Drainage Strategy Addendum

Project Name	Imberhorne Farm, East Grinstead
Client	Vistry Homes Limited
Project Ref	2206781
Report Ref	2206781_A-ACE-XX-XX-RP-C-0311
Report Title	Technical Note – Drainage Strategy
Date	01/04/2026

- 1.1. Ardent Consulting Engineers (hereafter referred to as 'Ardent') have been commissioned by Vistry Homes (the Client) to address the comments made by the West Sussex County Council (WSCC), as the Lead Local Flood Authority (LLFA), with respect to the proposed Outline Planning application (Ref.DM/26/0131) at Imberhorne Farm, East Grinstead. See **Appendix A** for the LLFA comments (REF. DM/23/2699).
- 1.2. This is in response to the Lead Local Flood Authority (LLFA) comments of the 13th February 2026 with the key points set out below in their objection requesting more information. Refer to **Appendix A** for LLFA correspondence.
- 1.3. Each comment is taken in the following section, in turn, and Ardent's response provided immediately below.

Drawing Title: SURFACE WATER FLOOD PLAN

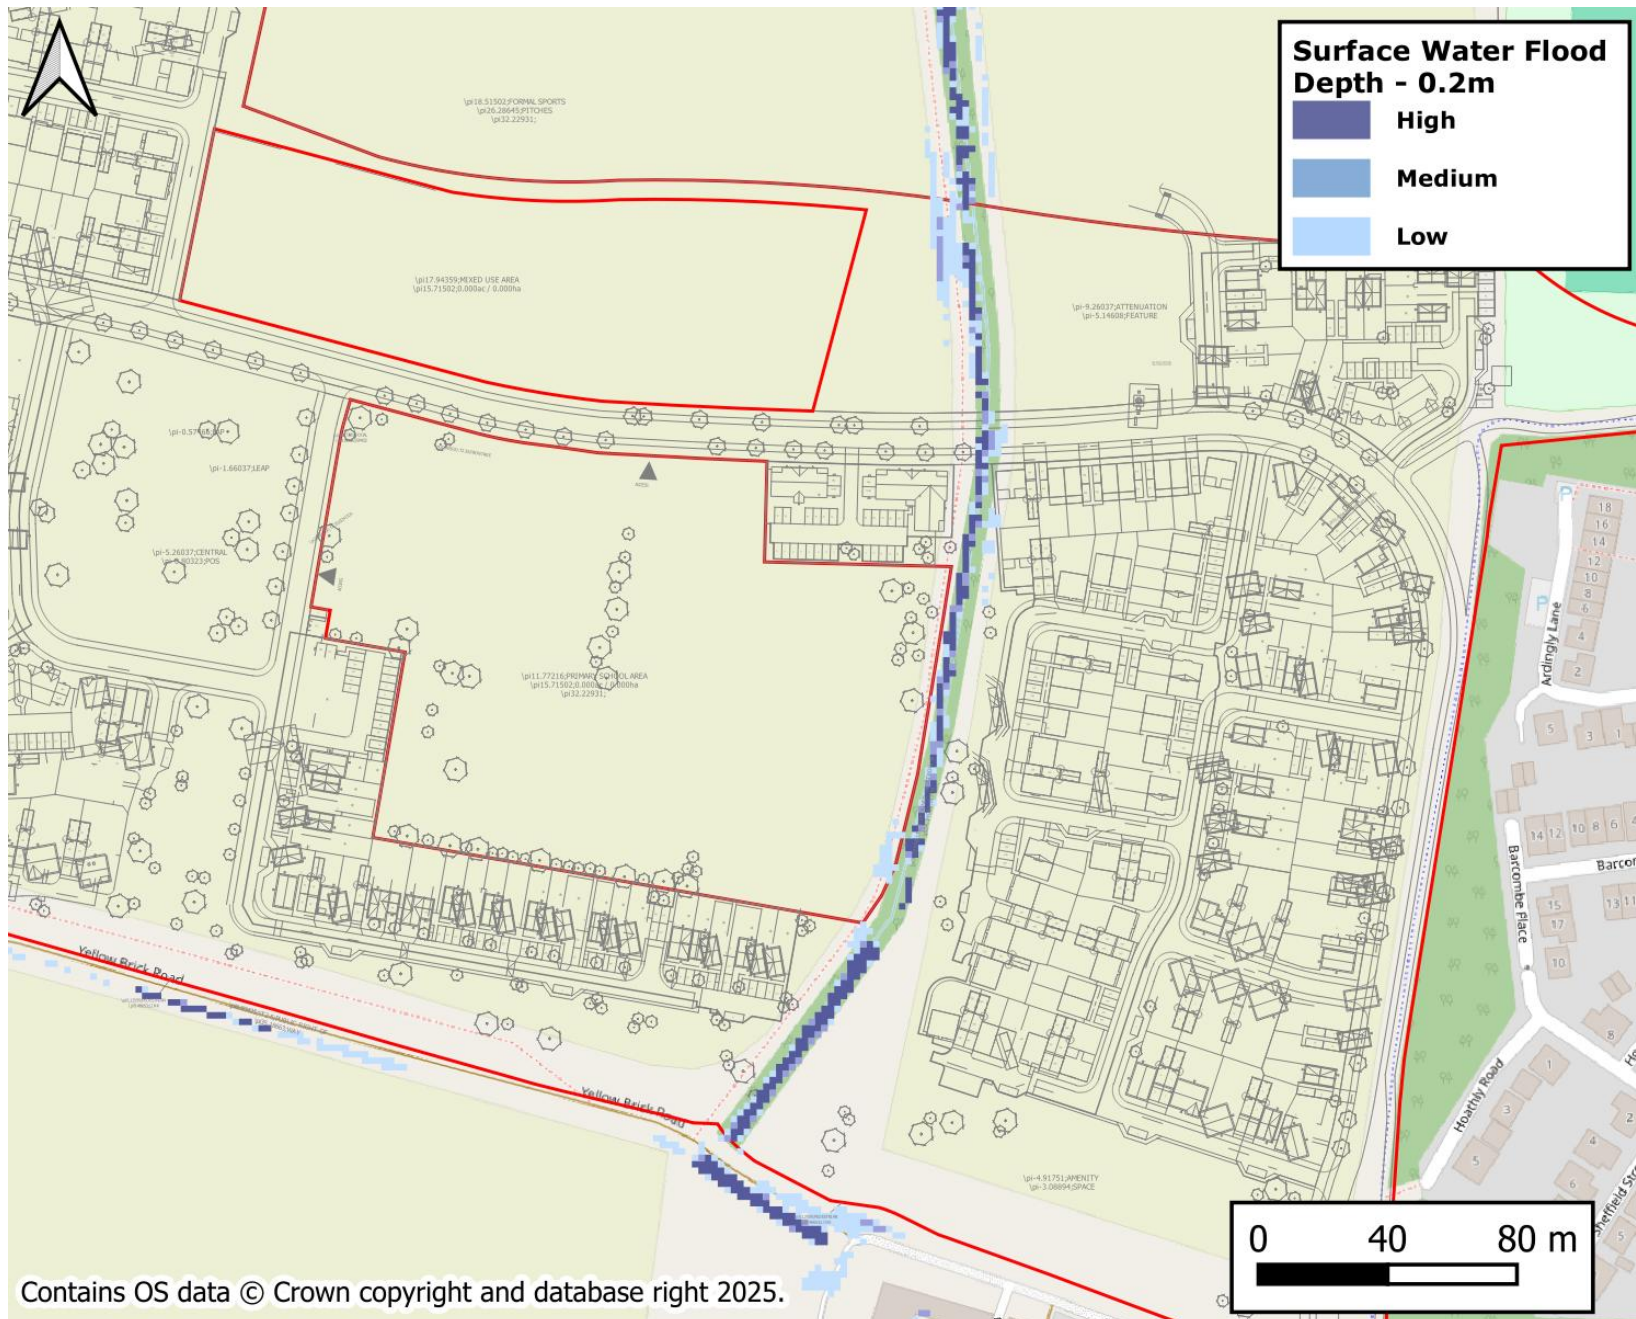
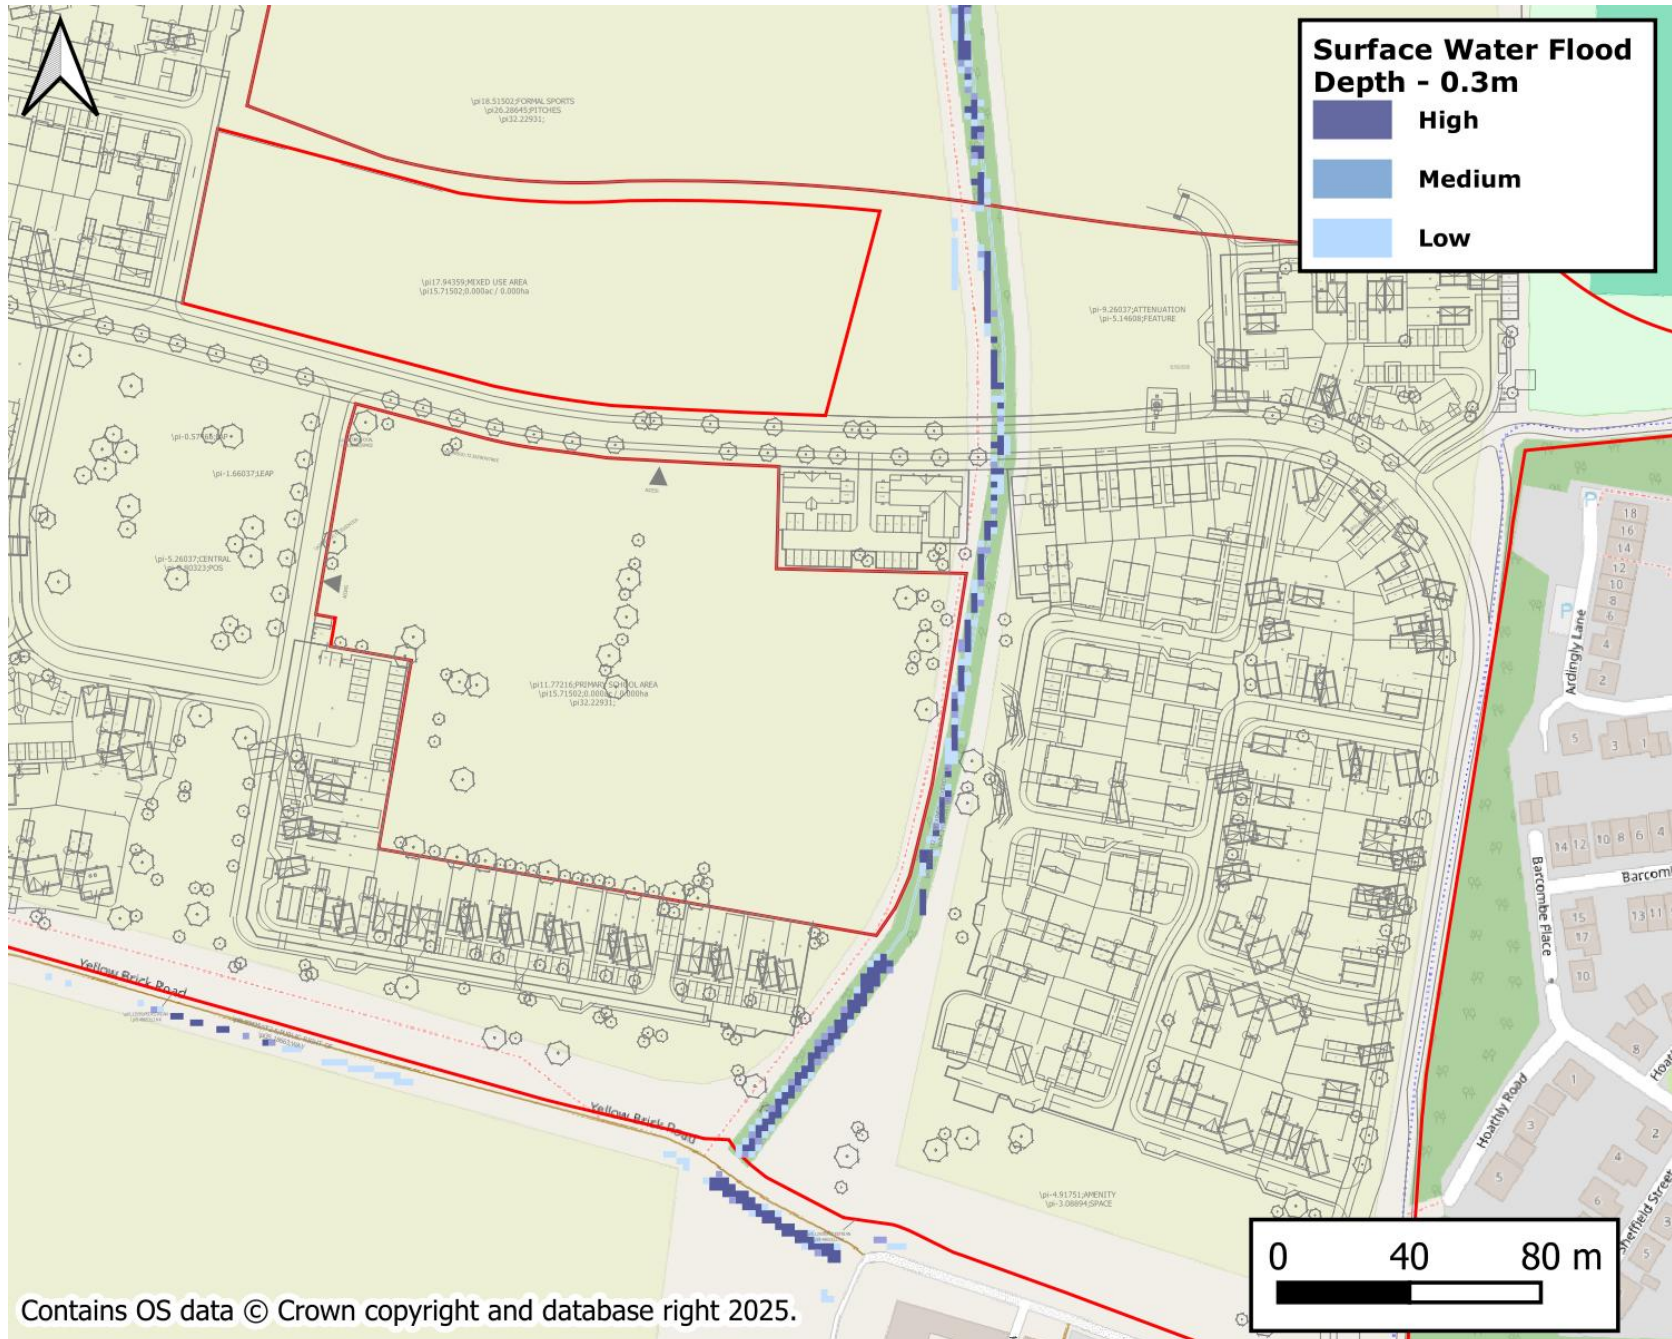
1. The LLFA notes that surface water flow paths exist now and into the future (West, Central and East). Please clarify by overlaying the proposed layout over Surface Water Flood Risk Mapping that no properties are within and there are appropriate buffers, easements provided. Please annotate and potential exceedance, extent and depths as appropriate.

- 2.2. Please refer to Drawing No.2206781-ACE-XX-00-DR-C-0627 - Rev P1 - Surface Water Flood Plan included in **Appendix B**, which shows EA flood risk mapping overlayed onto the site layout which demonstrates that the surface water flood extents are contained within the watercourse during the design event. The EA NaFRA2 flood depths dataset also shows that there are no flood depths exceeding 300mm outside of the watercourse, with some flooding between 200-300mm to the north of the site where the sports pitches are located, refer to **Appendix B** for flood depth mapping.

- 2.3. It is worth noting that the two flow paths in the west of the site originate from within the site itself and therefore this risk would be removed by the implementation of the development drainage strategy.
